SUTHERLAND SHIRE COUNCIL ASSESSMENT REPORT

Panel Reference	PPSSSH-47
Application Number	RA20/0010 and DA19/0786
LGA	Sutherland Shire
Proposed Development	Demolition of existing structures and construction of a health services facility
Street Address	398-402 Kingsway and 27 Flide Street, Caringbah Lots 7, 8, 9 and 37, DP 8147
Applicant	Irwin Medical Developments Pty Ltd
Date of lodgement	5 November 2020
Number of Submissions	18
Recommendation	Approval
Regional Development Criteria (Schedule 7 of the SEPP (State and Regional Development) 2011)	The application is referred to the SSPP as the development has a capital investment value of more than \$5 million and is nominated under Schedule 7 (5)(b) of SEPP (State and Regional Development) 2011. The application submitted to Council nominates the value of the project as \$20,465,000.
List of all relevant s4.15(1)(a) matters	<ul style="list-style-type: none"> • State Environmental Planning Policy No. 55 – Remediation of Land • State Environmental Planning Policy (State and Regional Development) 2011. • State Environmental Planning Policy (Infrastructure) 2007 • Sutherland Shire Local Environmental Plan 2015 • Sutherland Shire Development

Figure 4: Suns eye diagram Midwinter 9AM to 12PM

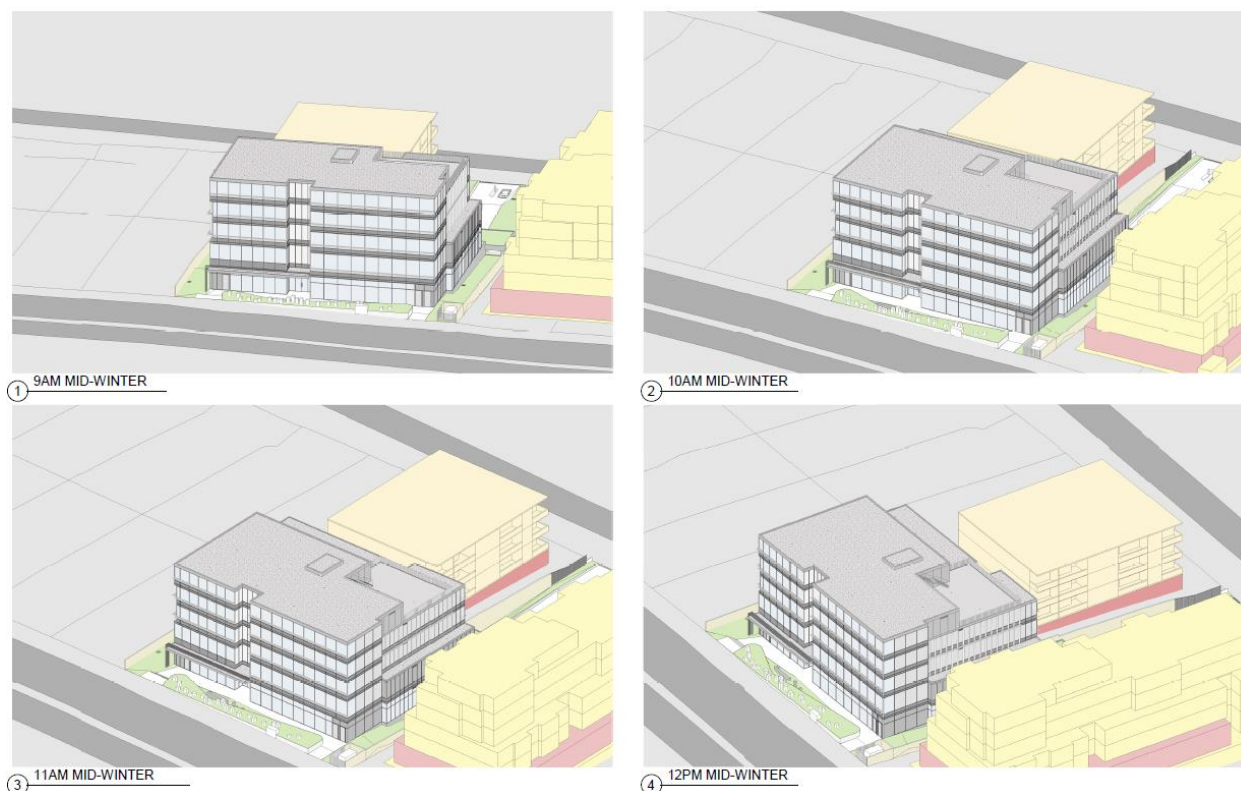
The proposed side setbacks are consistent with the building separation requirements specified within Chapter 9 of SSDCP 2015, and/ or as anticipated by the Building Envelope Plan. It is noted that the proposal deviates from the Building Envelope Plan in relation to the north-western side which anticipates a 2 storey medical height, and a 14m setback provided to the upper floors. The intent of this envelope is to maintain building separation between the upper level residential components as required under the Apartment Design Guide, and to provide for solar access to the lower 4 storey components at the upper levels to the rear (Flide Street). The proposal will attain the required building separation to approved (but yet to be constructed) development adjoining on the north-western side, and relies on the identified Building Envelope Plan to achieve the separation to the south-east. It is noted that windows along both side elevations, where they align with residential development are treated with 'no vision glass panels' and/ or louvres to ensure that visual privacy is maintained. The upper fifth level of the building is concentrated toward Kingsway, maintaining the stepping toward Flide Street, and the envisaged 4 storey envelope on the rear lots. The applicant has provided suns-eye diagrams which demonstrate that the required solar access will be provided to the rear, and that greater than 70% of apartments in their scheme would achieve compliance with the ADG in a four storey form, with 25% medical at the lower level. See Figure 4 and Figure 5 below.

Figure 10: Potential redevelopment - 75% Residential and 25% Medical

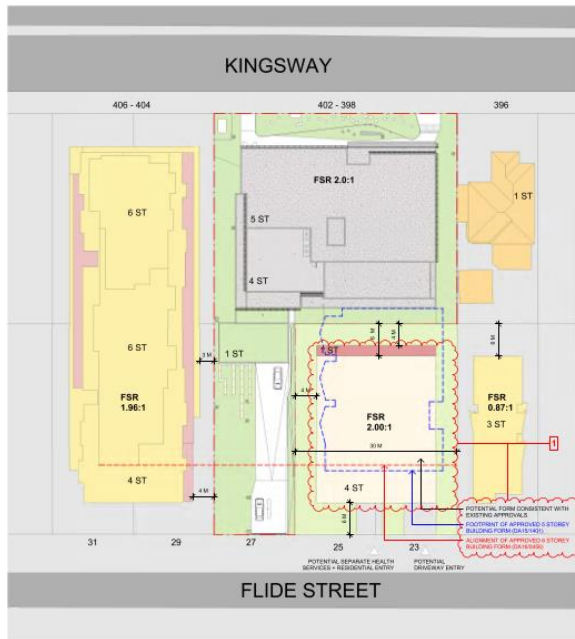
The isolated lots are capable of being consolidated, and together they achieve a frontage width of 30.48m, which exceeds the 26m minimum width specified within clause 5.2.3 of Chapter 9, SSDCP 2015. During the assessment of the subject application, the applicant has provided 2 indicative redevelopment schemes for No. 23 and 25 Flide Street, one with 100% medical over floor levels, and another with 25% medical on the lower floor and three levels of residential above. Both schemes are indicated below.

Although indicative, both schemes demonstrate that it is possible to produce floorplates that will achieve close to the maximum permissible floorspace, maintain the 4 storey height identified in the building envelope plan, and are capable of compliance with the setback and landscape area requirements. Further, overshadowing diagrams have been prepared which demonstrate that 73% of apartments within that design will achieve the Apartment Design Guide required solar access to a living and private open space area. Such a scheme will maintain the stated transition in building height to Flide Street.

Figure 13: Sun's eye shadow diagram midwinter 9AM to 12PM

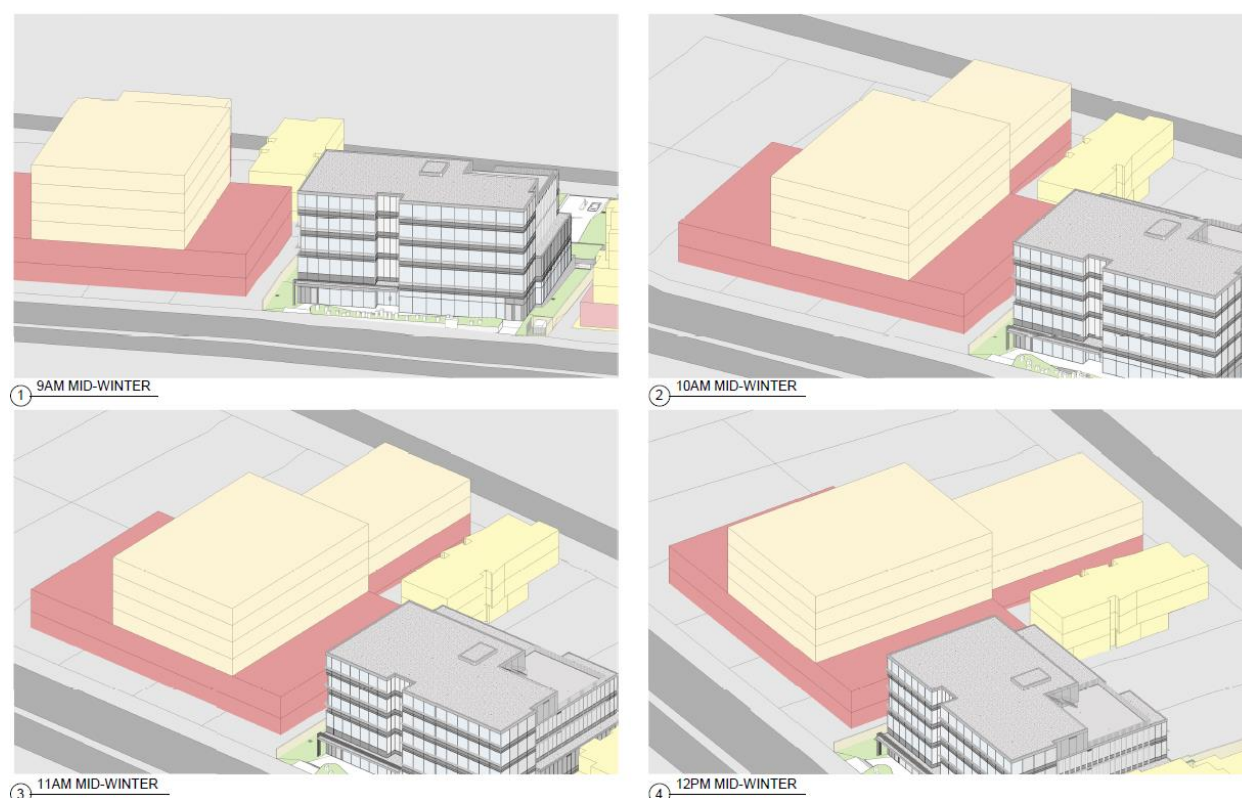
Clause 14.2.5 of Chapter 9 contained in SSDCP 2015 stipulates for neighbouring properties that '*direct sunlight to north facing windows of habitable rooms and 10m² of useable private open space areas of adjacent dwellings should not be reduced to less than 2 hours between 9.00am and 3.00pm on 21 June*'.

Overshadowing from the building will reduce solar access to north facing living spaces of the existing dwelling at 396 Kingsway to less than 2 hours between 9am and 3pm, however will achieve the required 2 hours to the rear garden. This is largely as a result of the orientation of the site. It is also noted that the SSDCP 2015 anticipates that 396 will be redeveloped, with the lower 2 floors dedicated for medical use. Whilst larger side setbacks would reduce the impact somewhat, the south eastern side setback is consistent with the recommended amalgamation and building envelope plan for Site 14 and the applicant's shadow diagrams indicate that the proposal will maintain greater than 2 hours the anticipated location of residential development on that lot as envisaged by the SSDCP 2015 and as such the development is deemed acceptable. See Figure 13 and Figure 14 below.
